Addendum 02

PROJECT: New Castle CSC Turf Softball Field
2200 South Main Street
New Castle, Indiana 47362

PROJECT #: 26059.00

ARCHITECT: Garmann Miller
38 South Lincoln Drive
P.O. Box 71
Minster, Ohio 45865

SHEET NUMBER: **C1.1**

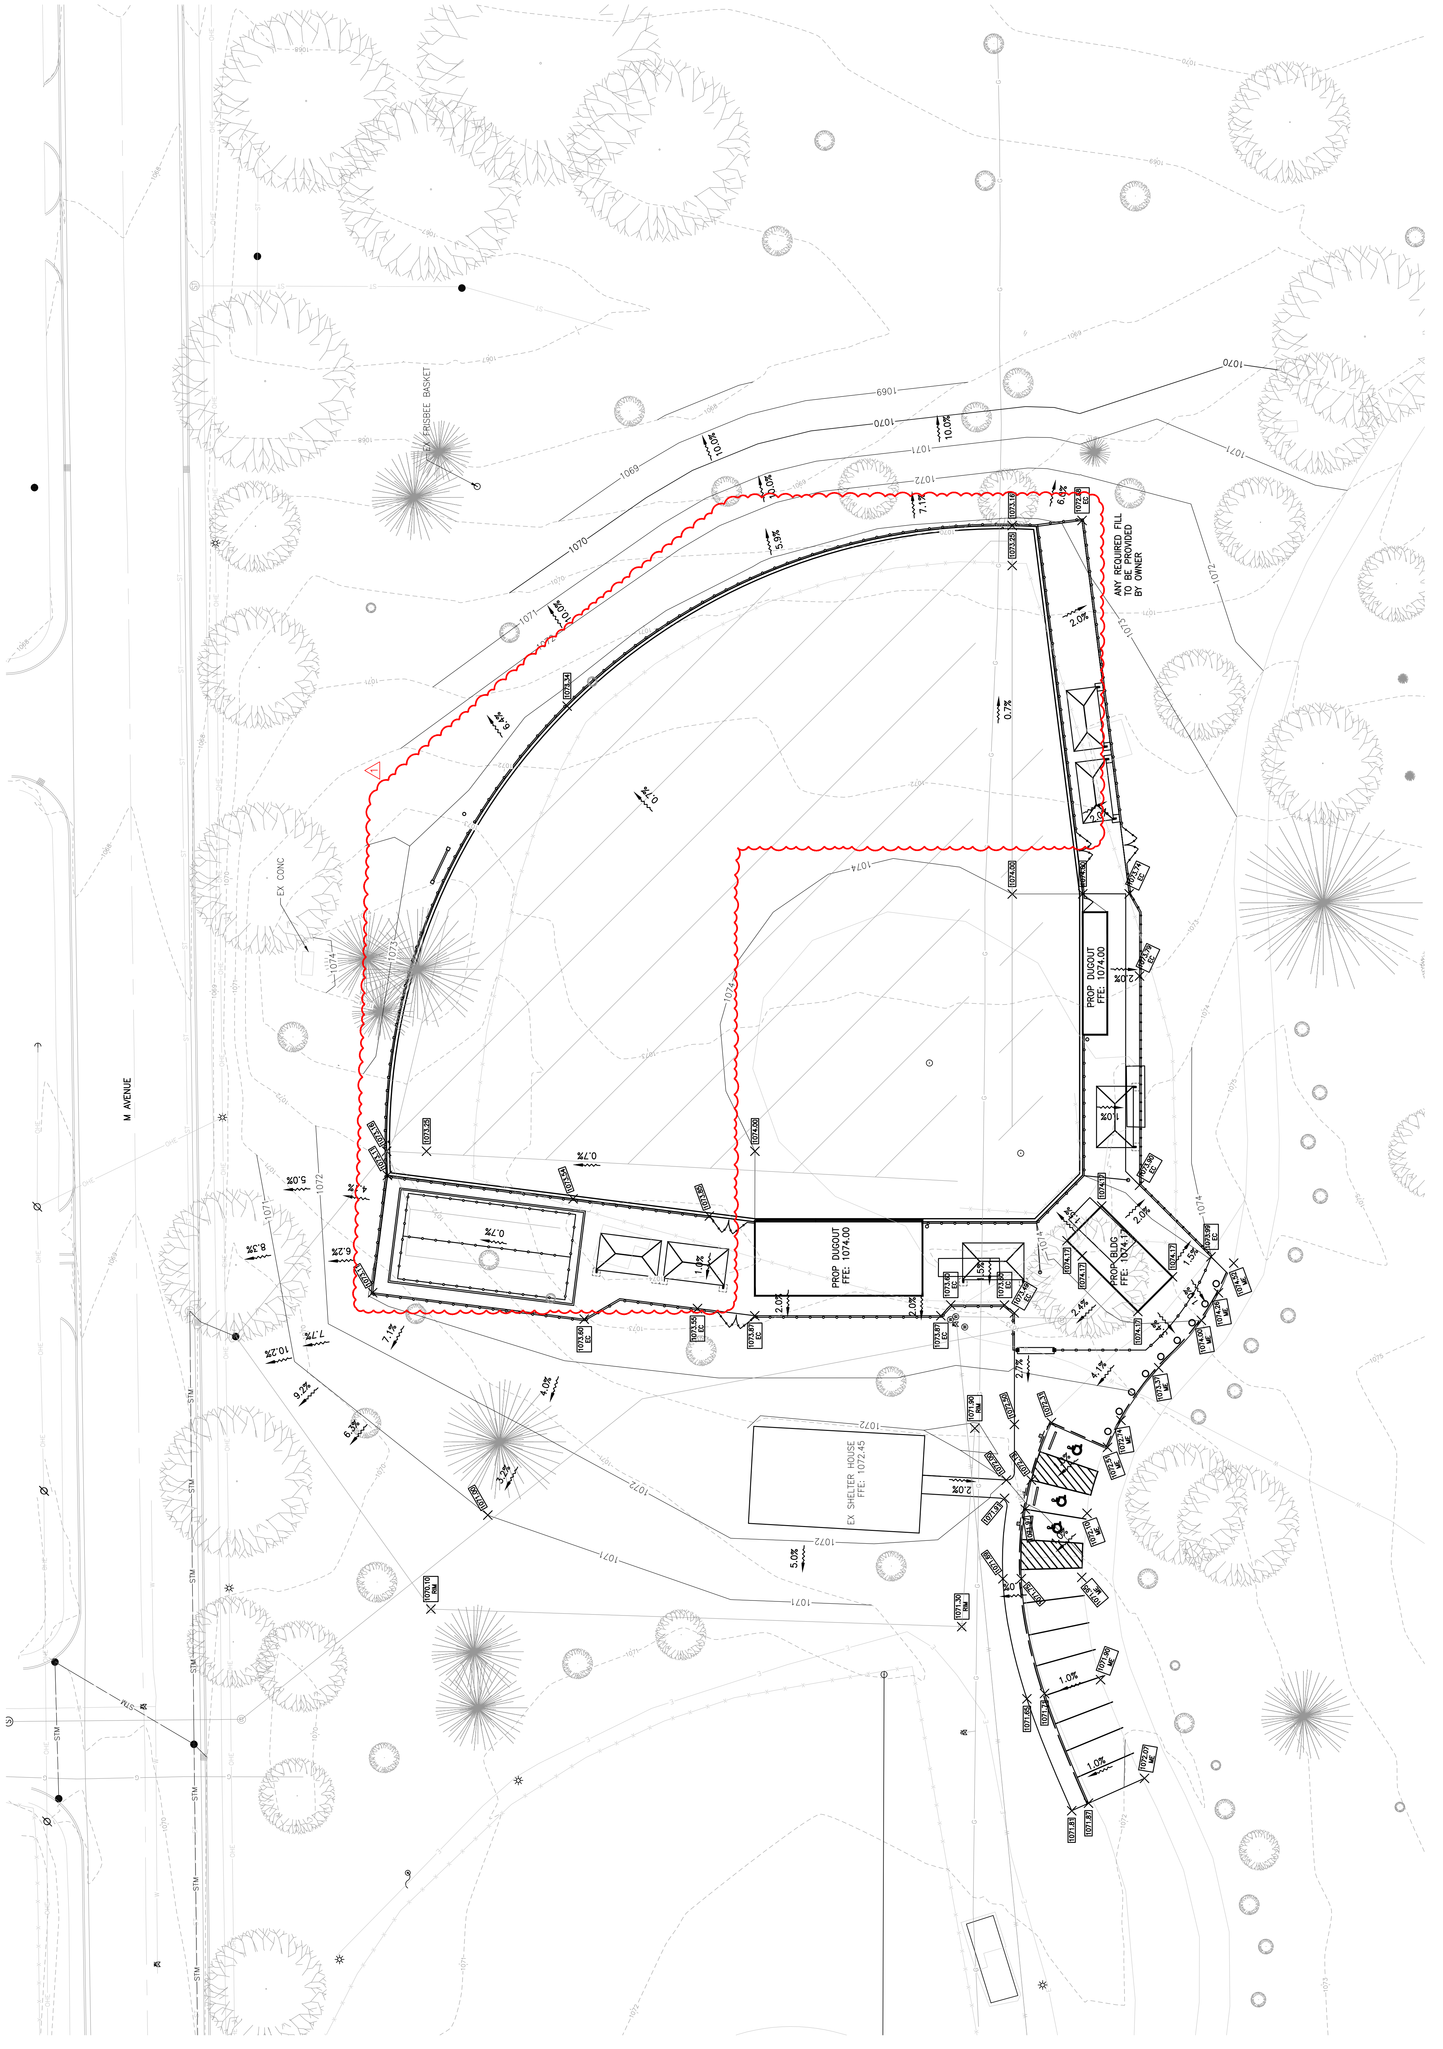
1. Drawing C1.1
    a. Modified grading in outfield to 0.7%
2. Drawing C1.2
    a. Added yard drain, underdrains, storm sewer, and sanitary sewer information

EROSION CONTROL & DETAILS

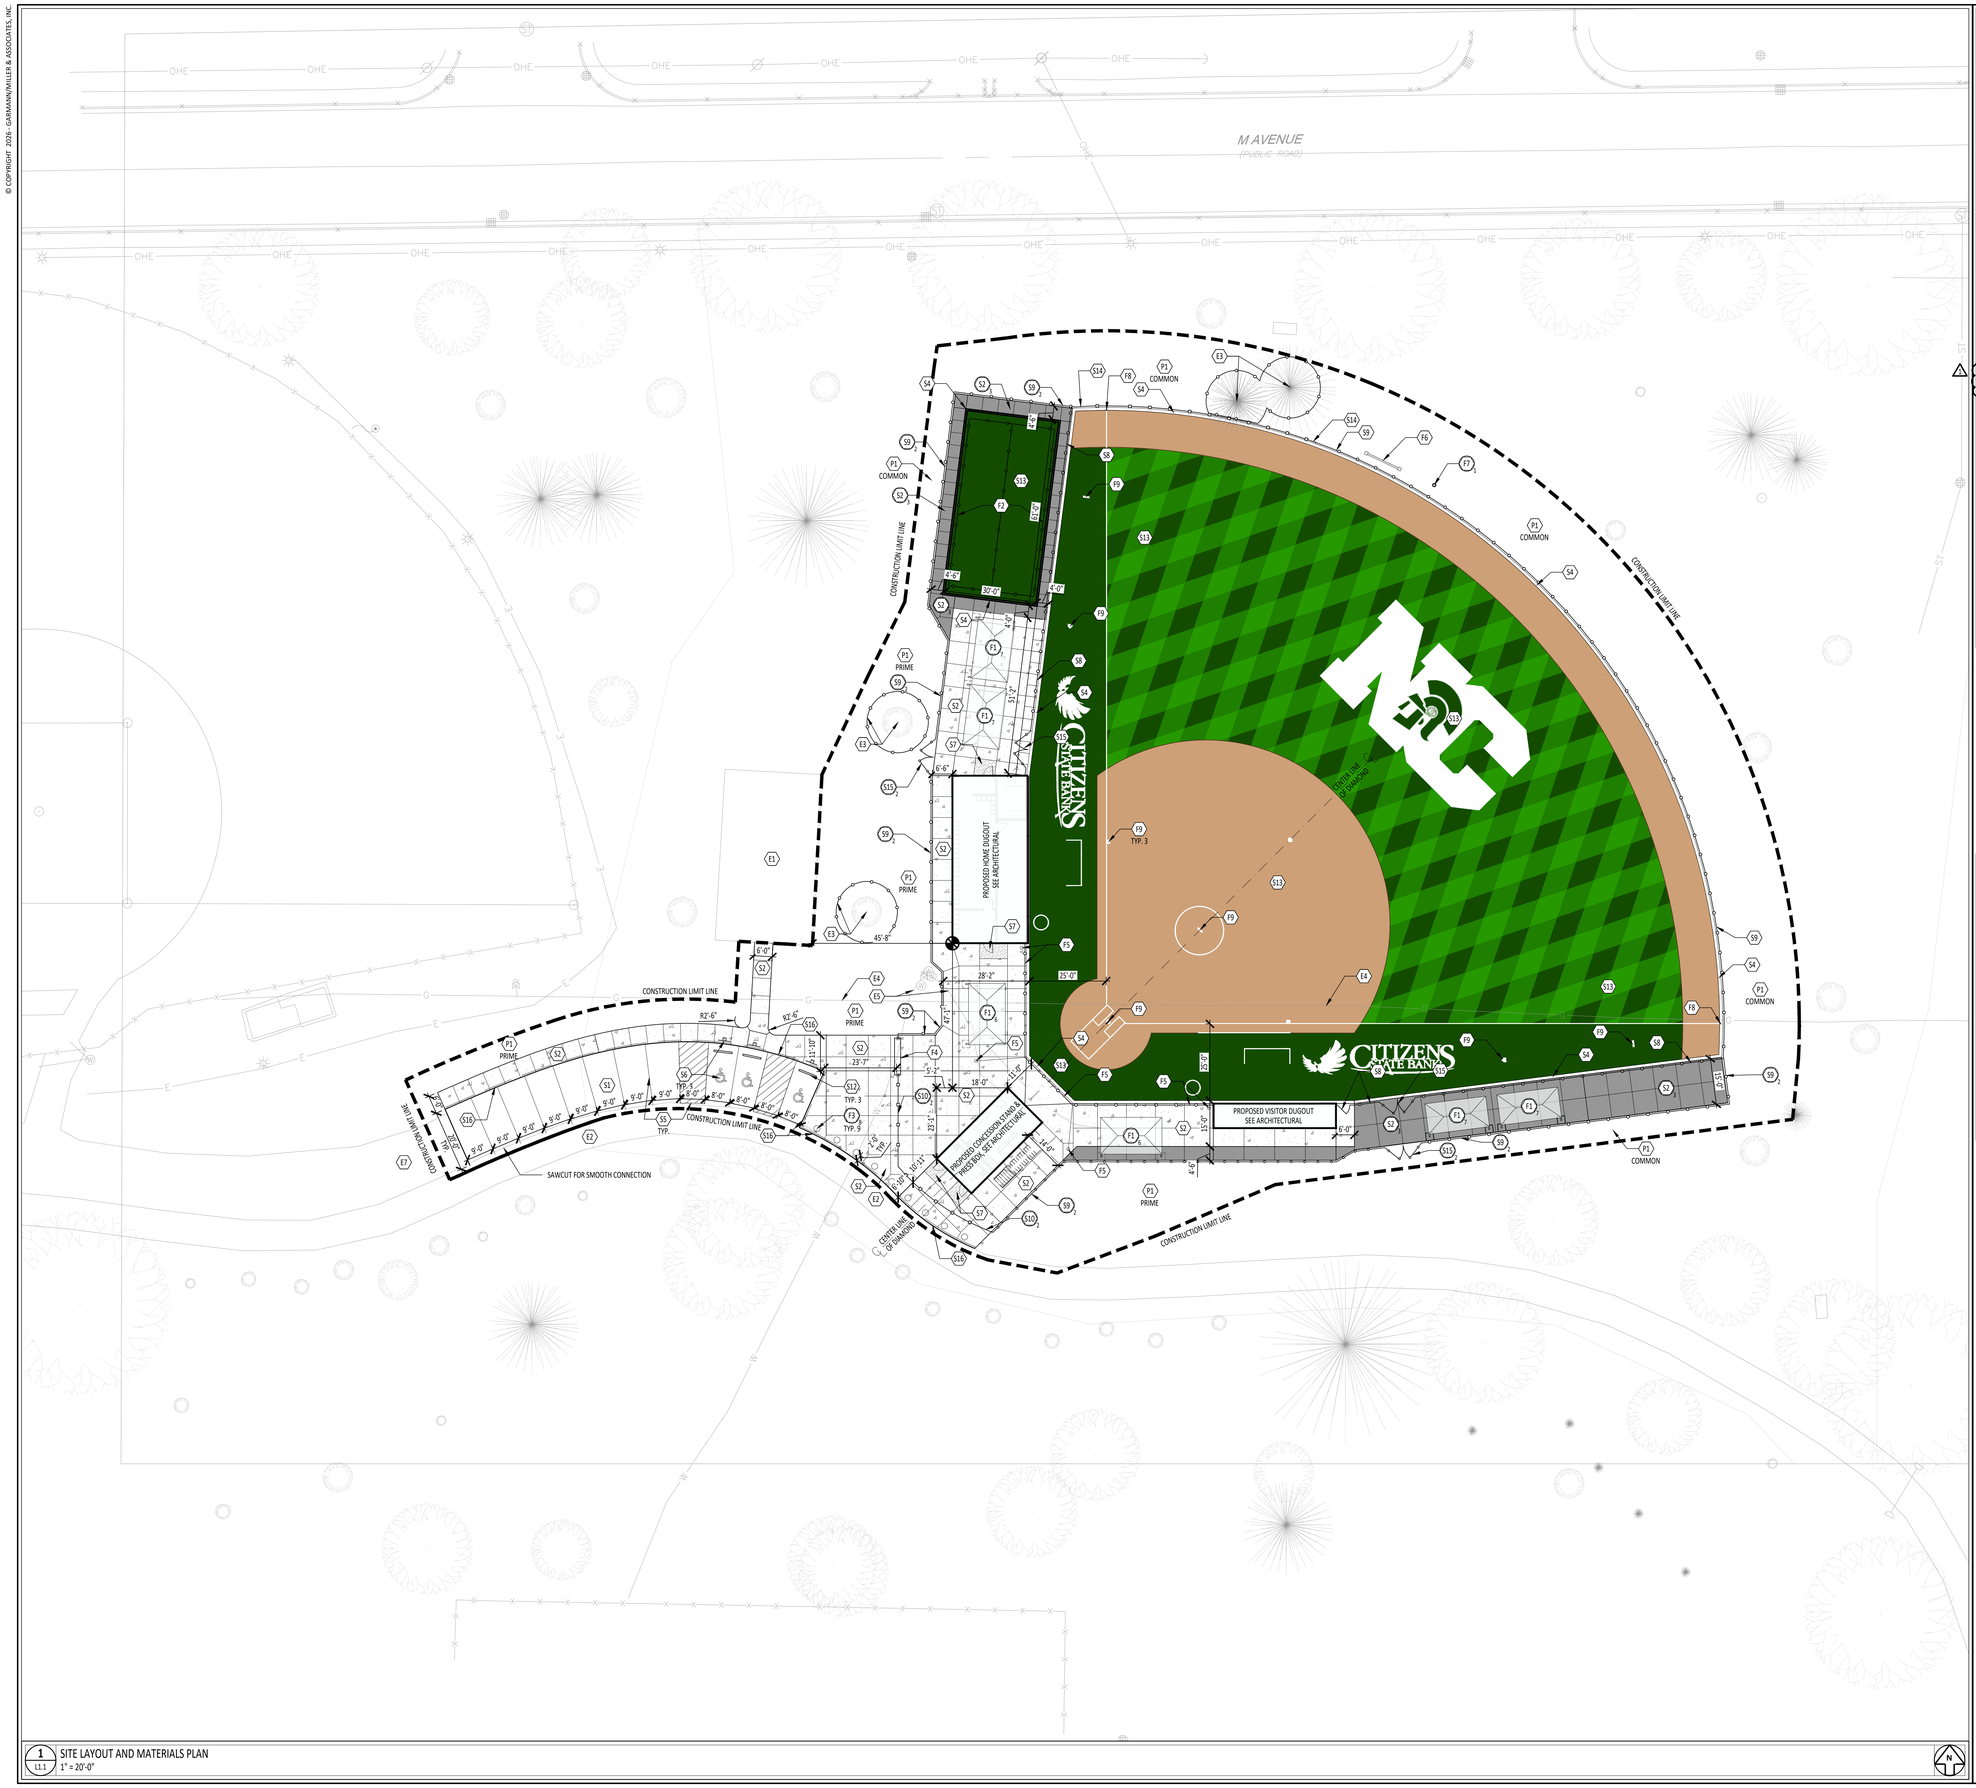
e. Added note to coordinate the upsizing of the water line with the city
3. Drawing C1.4
    a. Added underdrain in baseball field area detail
4. Drawing L1.1

L2.1

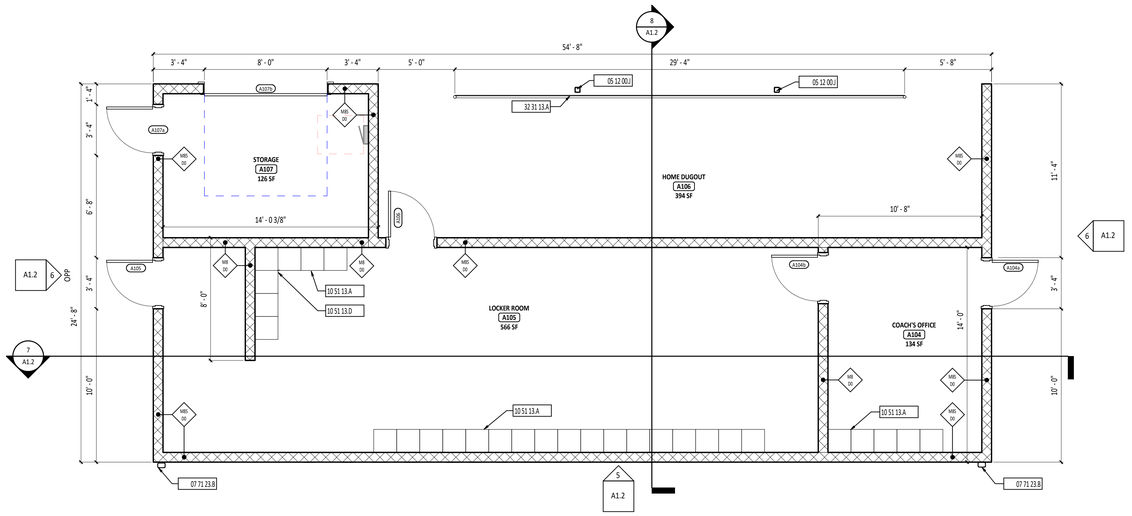
a. Added note for turf to be provided by owner and installed by contractor.
5. Drawing L2.1
    a. Added note for turf to be provided by owner and installed by contractor.

5 L2.1 SYNTHETIC TURF STONE BASE
1" = 1'- 0"

PLANS - DUGOUTS

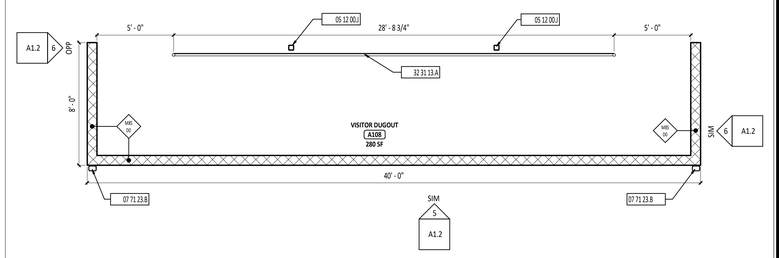
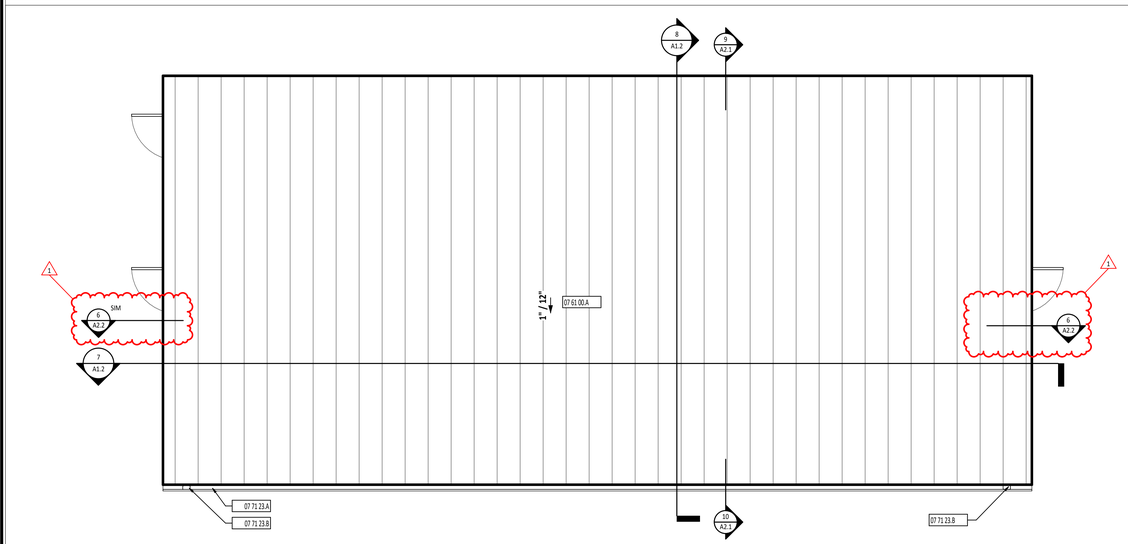
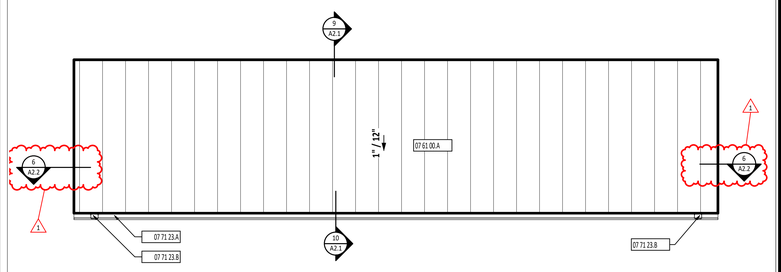
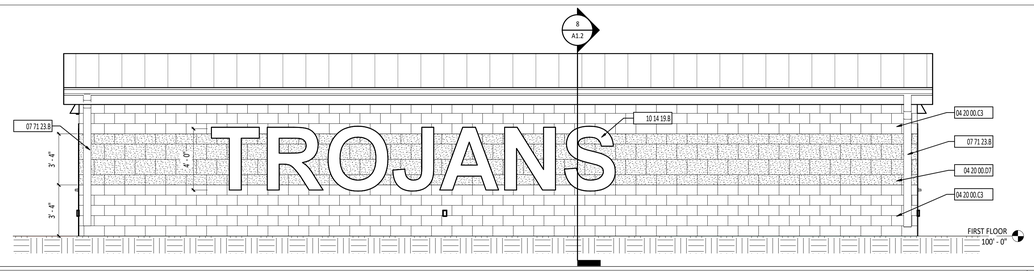
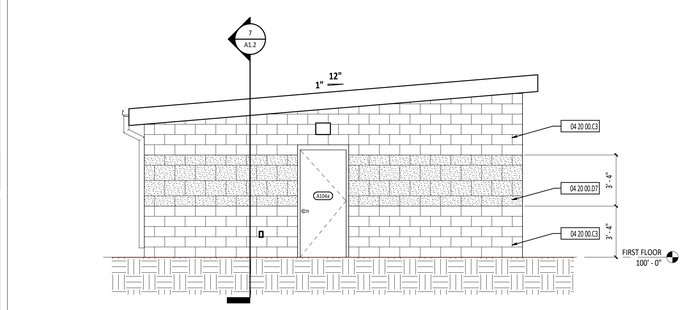
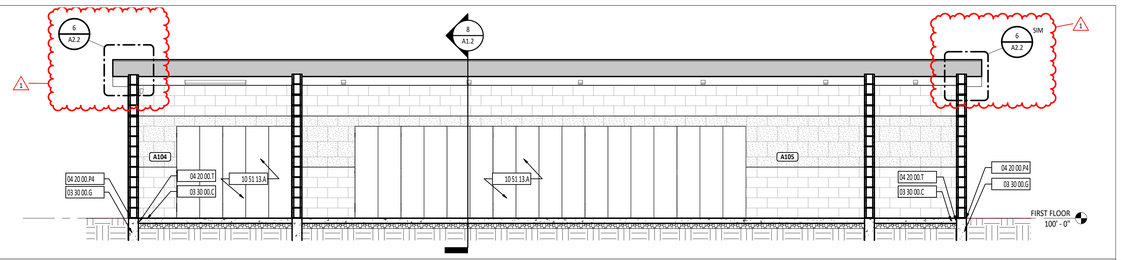
6. Drawing A1.2
    a. Added section detail callouts
7. Drawing A2.2
    a. Added section details
8. Drawing A9.1
    a. Modified the Metal Locker Schedule, Marking section to the correct locker listed on specs.

FIRST FLOOR FINISHES PLAN

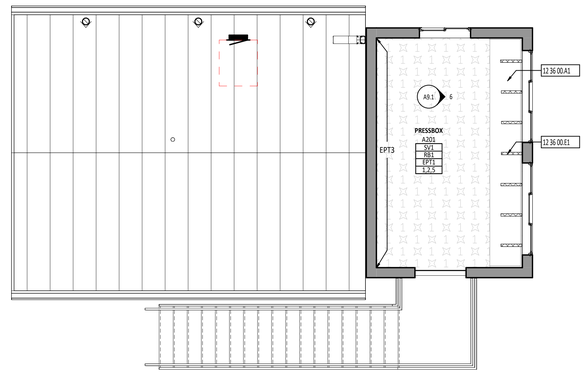
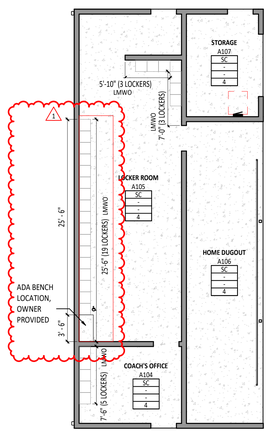
b. Modified the First-Floor Plan- Home Dugout floorplan to accommodate an ADA benching location.
9. Drawing P2.1
    a. Added RPBP and water meter. Added note to install in an accessible location from the plumbing chase access door.

PLUMBING PLANS, DETAILS, AND SCHEDULES

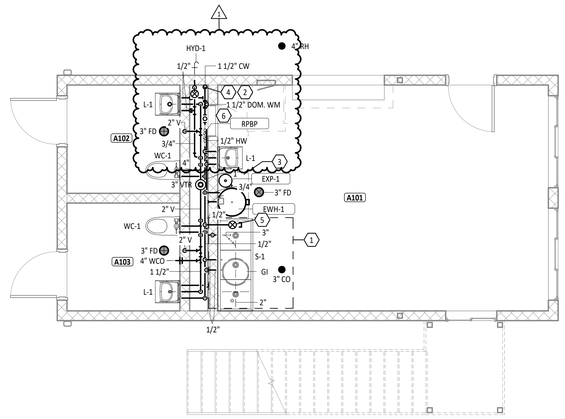
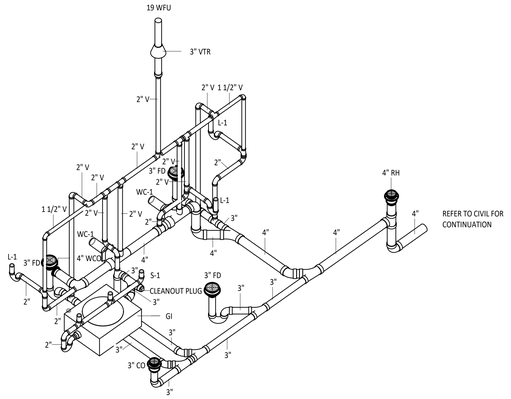
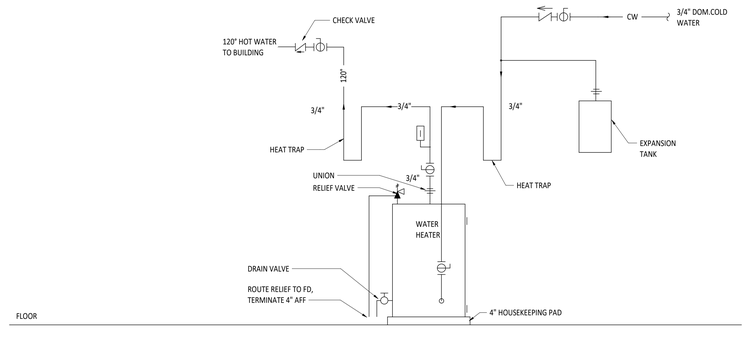
b. Modify domestic water piping to accommodate RPBP and water meter.
    c. Revised location of the water hammer arrestor so it is in an accessible location
